**RE: RIN: 0920-AA33; Total Inward Leakage Requirements for Respirators:  
Notice of Proposed Rulemaking**

### **3M Company Comments**

3M Comments on 42 CFR Part84 Docket Number 137, NIOSH Proposed Rule  
on Total Inward Leakage Requirements for Respirators  
[74 FR 56141]

Figure 1: TIL Test Results presented at NIOSH/NPPTL TIL Public Meeting

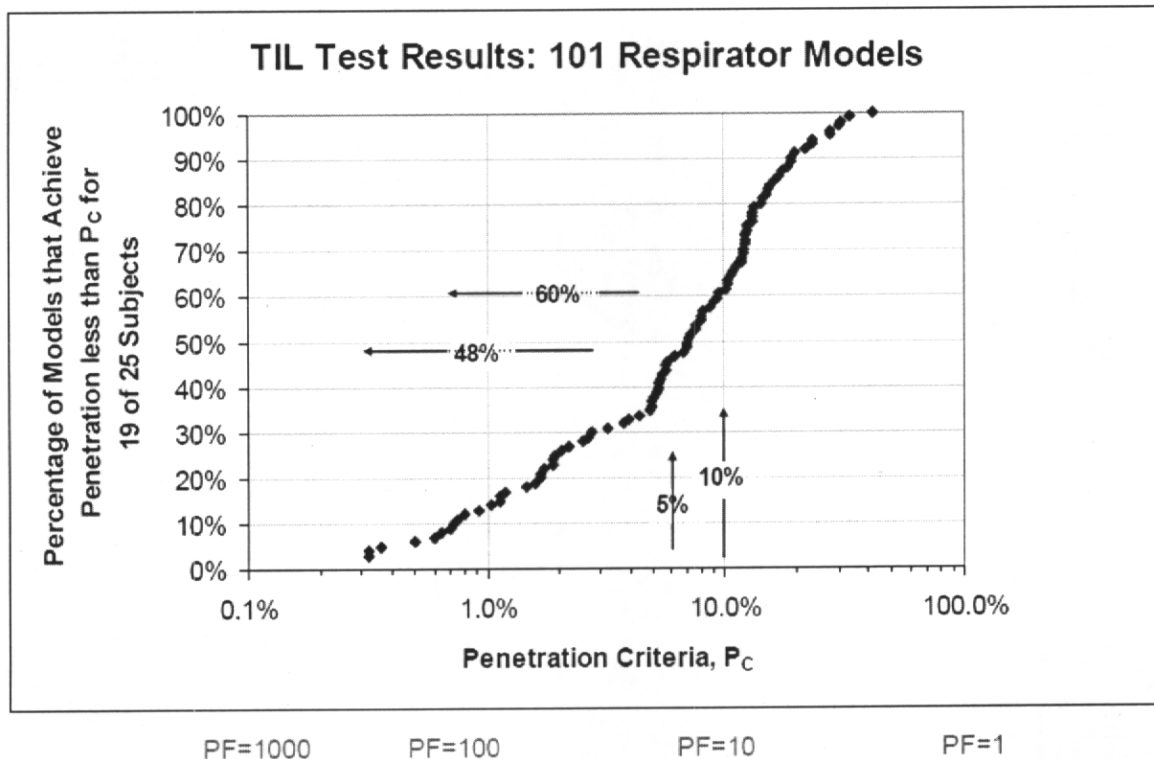
This slide indicates that using a 10% penetration criterion (fit factor of 10) resulted in 60% of the 101 tested models meeting this criterion. Using a 5% penetration criterion (fit factor of 20) 48% percent of the models tested met the criterion. Using a 1% penetration criterion (fit factor of 100), as proposed in this rule, only 15 % of the 101 models of both elastomeric and filtering facepiece half mask respirators met the criterion. This means 85% of this class of respirators have “facepiece seals that did not perform” to this criterion, not the “approximately 30 percent of this class” as stated by NIOSH (74 *Federal Register*, p. 56142). NIOSH later inexplicably concludes that, “For the leading

Figure 2: TIL Test Results presented at NIOSH/NPPTL TIL Public Meeting

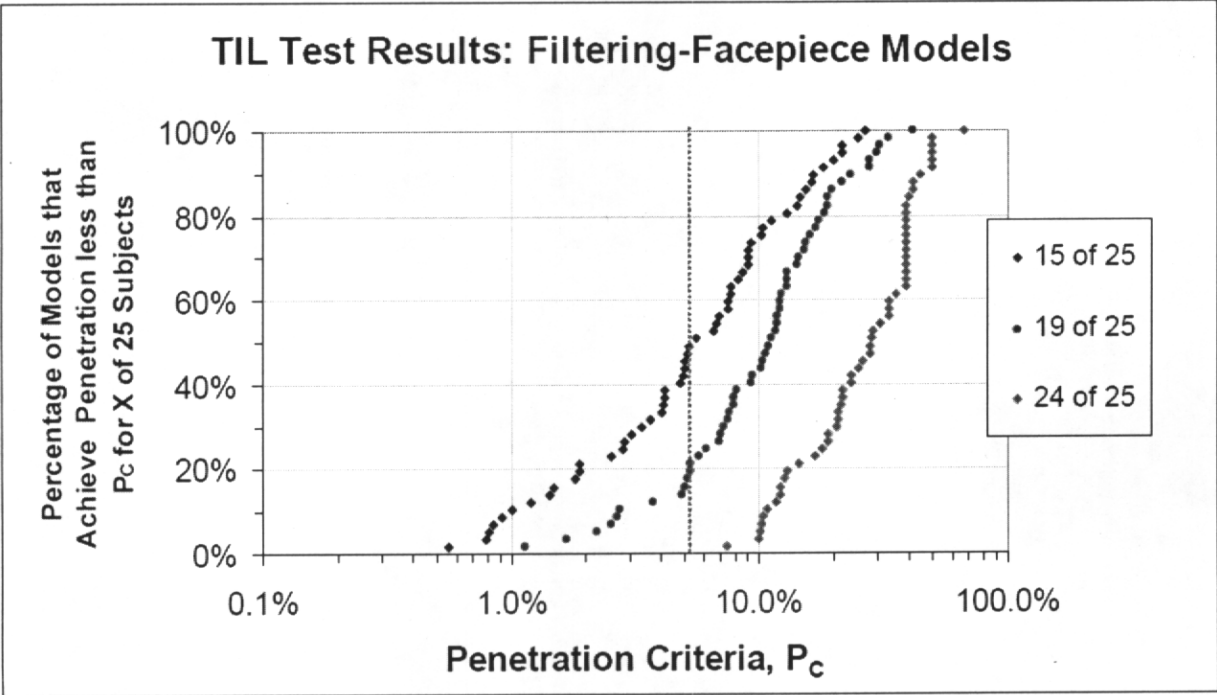
Figure 2, which is based on filtering facepieces included in the benchmarking data, allows for a more direct comparison to the proposal as it provides three different lines for different panel passing percentages for filtering facepiece respirators. If one looks at the line for 19 out of 25 (76%) of the panel passing, which is close to the 74-75% pass rate being proposed, 100% of all filtering facepiece respirators tested would be eliminated form the market at the 1% penetration criterion (fit factor of 100).

Based on analysis of these data, the number of products needing to be redesigned is greater than the 30% mentioned by NIOSH. This will dramatically increase the time and money required to redesign the respirators that would be eliminated from the market. It

Figure 3

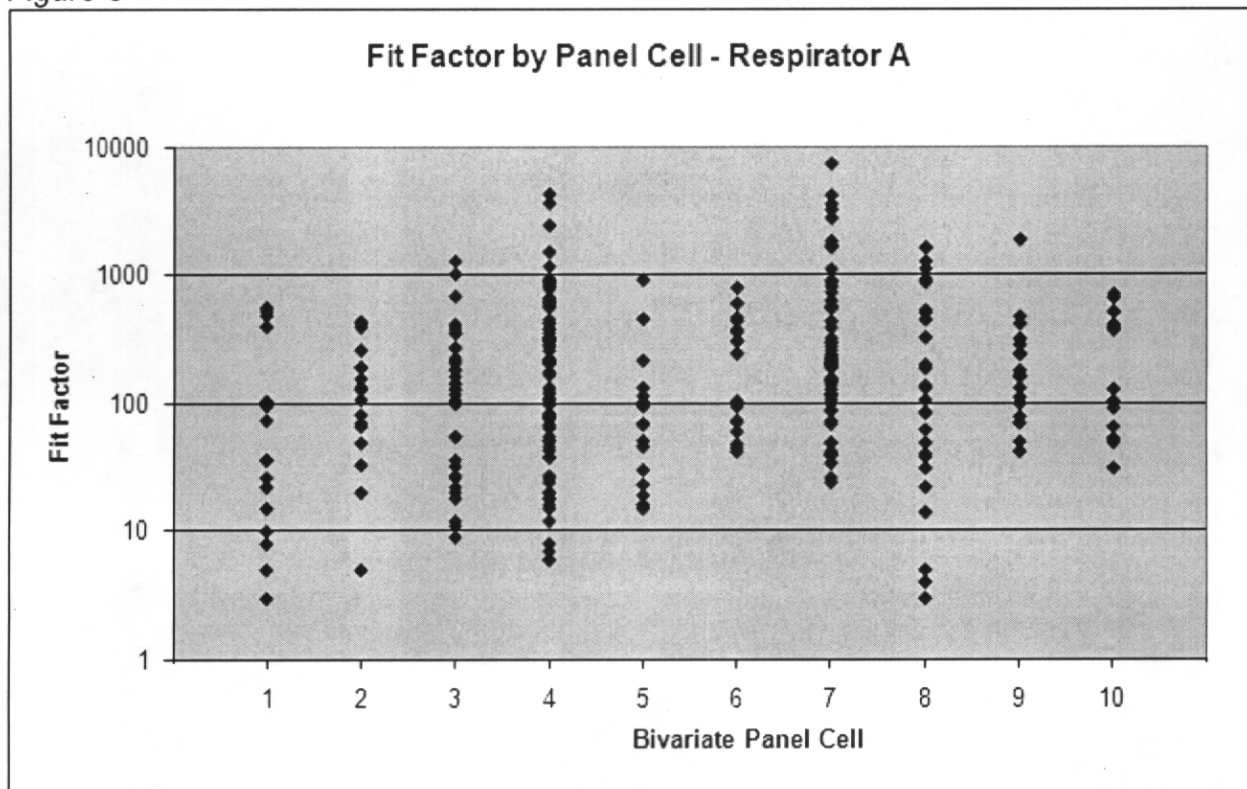
This proposal requires respirators fit a large variety of facial shapes and sizes. 3M supports this requirement. Based on fit testing results of large numbers of subjects, our data indicate filtering facepiece respirators are capable of fitting subjects in every cell of the NIOSH bivariate panel. Figure 3 shows the distribution of individual fit values versus NIOSH bivariate panel cell for 105 subjects tested three times each on a well-accepted 3M filtering-facepiece respirator. The respirator fits some subjects in each panel cell well (fit factor  $\geq 100$ ) and does not fit other subjects in the same cells as well (fit factor  $< 100$ ).

However, based on the proposed small sample sizes of 35 people the proposed test procedure is unable to demonstrate that any particular respirator model satisfactorily fits a large variety of facial shapes and sizes (see table 2). We believe this is due to the small number of subjects tested coupled with the wide variability in fit among subjects in the same cell. In the cell sizes that represent a small fraction of the likely end-user population, there are only two test subjects and given the large variability between subjects, the chances of failing are higher in these cells.

Figure A1 – Components of variance analysis for five well-accepted 3M filtering facepiece respirators

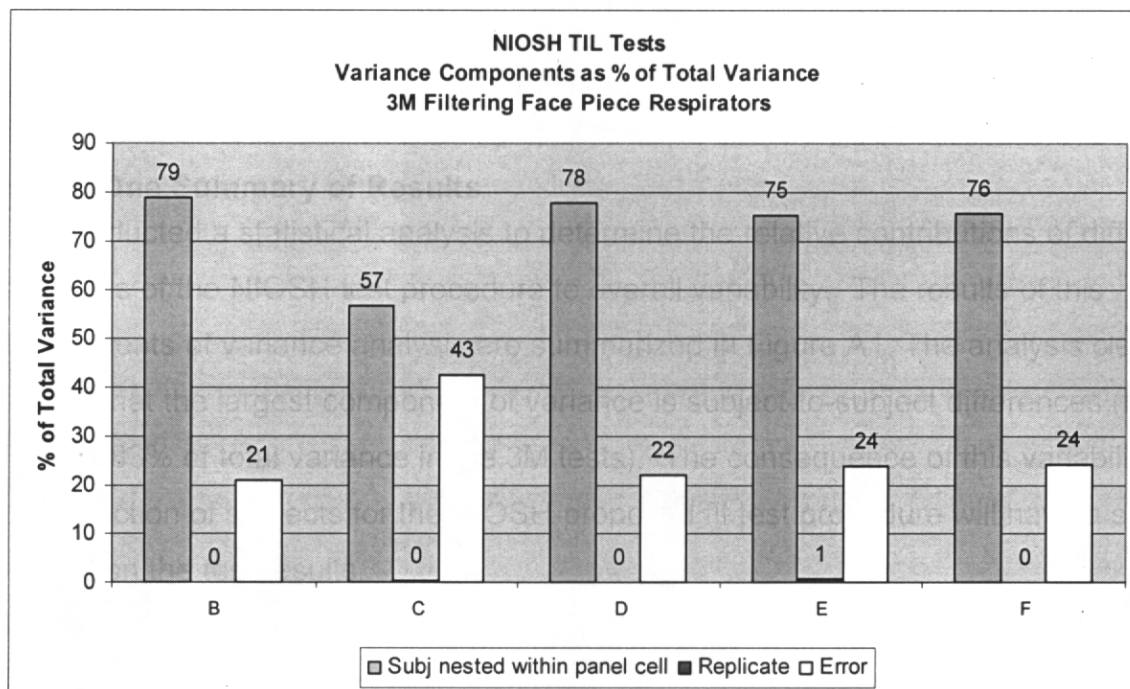
3M conducted a statistical analysis to determine the relative contributions of different elements of the NIOSH test procedure to overall variability. The results of this components of variance analysis are summarized in Figure A1. The analysis clearly shows that the largest component of variance is subject-to-subject differences (from 57% to 83% of total variance in the 3M tests). The consequence of this variability is that the selection of subjects for the NIOSH-proposed fit test procedure will have a strong impact on the test results.

*Figure A2 – Distribution of the number of subjects passing fit factor  $\geq 100$  or TIL  $\leq 1\%$  in 1000 simulated panels*

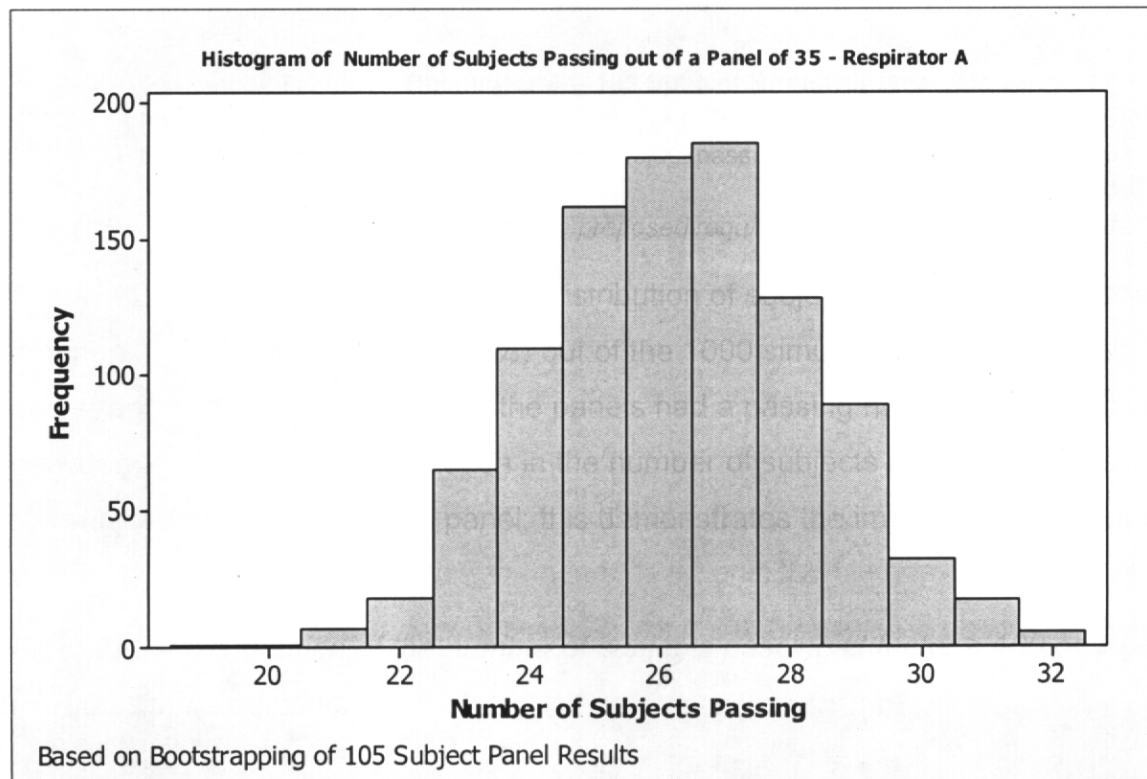
Figure A2 is a histogram showing the distribution of subjects passing the TIL pass/fail criterion (fit factor  $\geq 100$  or TIL  $\leq 1\%$ ) out of the 1000 simulated panels generated in the bootstrap study. Ninety percent of the panels had a passing number of subjects ranging between 23 and 29. Wide variation in the number of subjects passing is due solely to the subjects selected for each panel; this demonstrates the impact of subject-to-subject variability.

*Figure A3 – Components of variance analysis on 35-subject panel with three separate sessions on a single model of 3M filtering facepiece respirator*

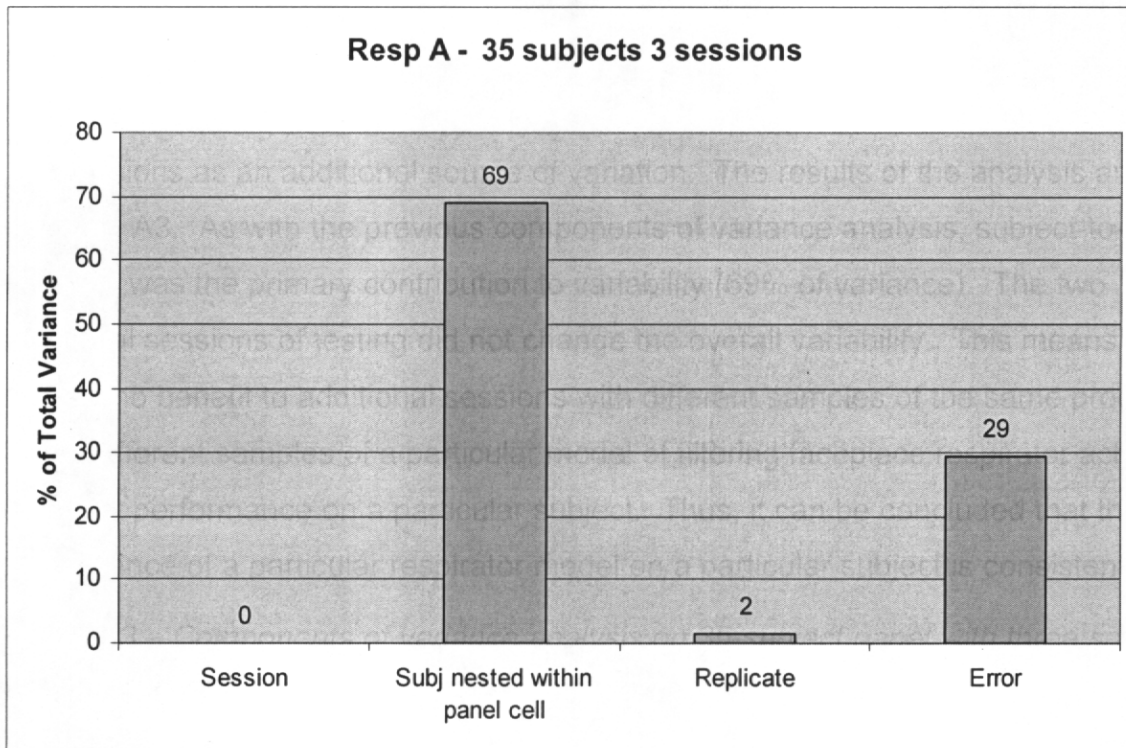
A components of variance analysis was conducted on study three, adding the repeat test sessions as an additional source of variation. The results of the analysis are shown in Figure A3. As with the previous components of variance analysis, subject-to-subject variation was the primary contribution to variability (69% of variance). The two additional sessions of testing did not change the overall variability. This means that there is no benefit to additional sessions with different samples of the same product. Three different samples of a particular model of filtering facepiece respirator achieved similar fit performance on a particular subject. Thus, it can be concluded that the fit performance of a particular respirator model on a particular subject is consistent.

Therefore, if NIOSH wishes to overcome the limitations imposed by the large amount of subject-to-subject variability, the only solution is to increase the panel size. There is minimal benefit to be gained from conducting repeated tests with a smaller group of subjects.
